IN THE MATTER of Bendigo-Ophir Gold Project (FTAA-2507-1089)

JOINT STATEMENT OF EXPERT WITNESSES:

**RECONVENED GEOCHEMISTRY / WATER QUALITY / HYDROLOGY /
WATER MANAGEMENT / FRESHWATER ECOLOGY**

10 June 2026

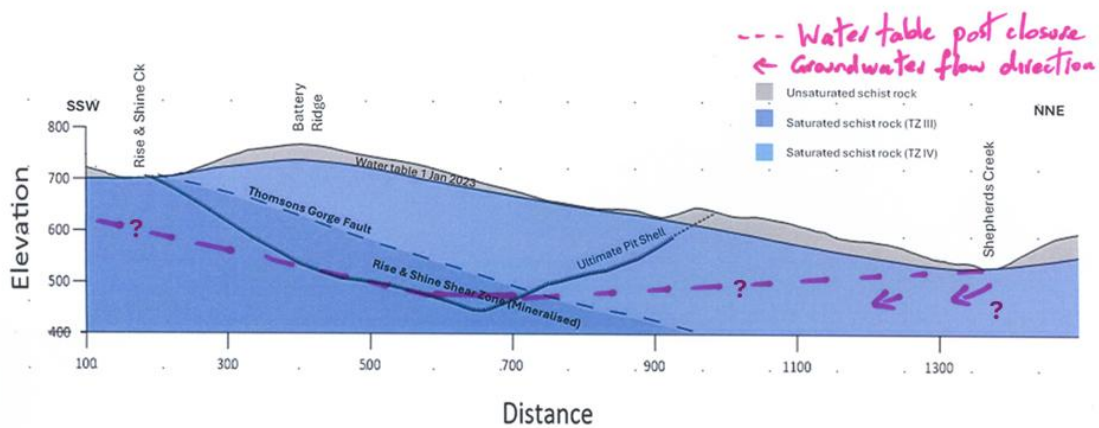
19. KM considers that while the proposed triggers above provide more detail, the time taken to collect performance data, interpret trends, and begin the lead-in time for active treatment, may result in a period of time of at least two-years, and likely more, before active treatment is fully implemented. While this occurs, effects continue.

20. PW considers that at the start of the project the geochemical risks are likely to be low, increasing with time that enables observance of trends and identification of management procedures.

(ii) Post closure maintenance / operation of the water treatment plant (both active and/or passive): Is this adequately addressed / provisioned for? Duration of active treatment

21. MP, JW and AB consider that post-mine closure, financial provision and mechanisms are needed for the long-term management of the water treatment systems. PW and MP refer to the Geotech JWS dated 12 May 2026 at [22] and endorse the recommendations within that paragraph.
22. PW notes that the NP20 model indicates that active treatment is required for approximately 50 years until passive treatment can be initiated, noting further work needs to be done on the passive treatment system to confirm its treatment efficiencies. More conservative models suggest that the timeframe could be longer.
23. KM cannot comment on the financial aspects but agrees there needs to be an enduring responsibility for treatment to manage the long term effects into the future.

(iii) Passive treatment viability: considering potential water quality and volumes. Is this adequately addressed / provisioned for?
Duration of passive treatment
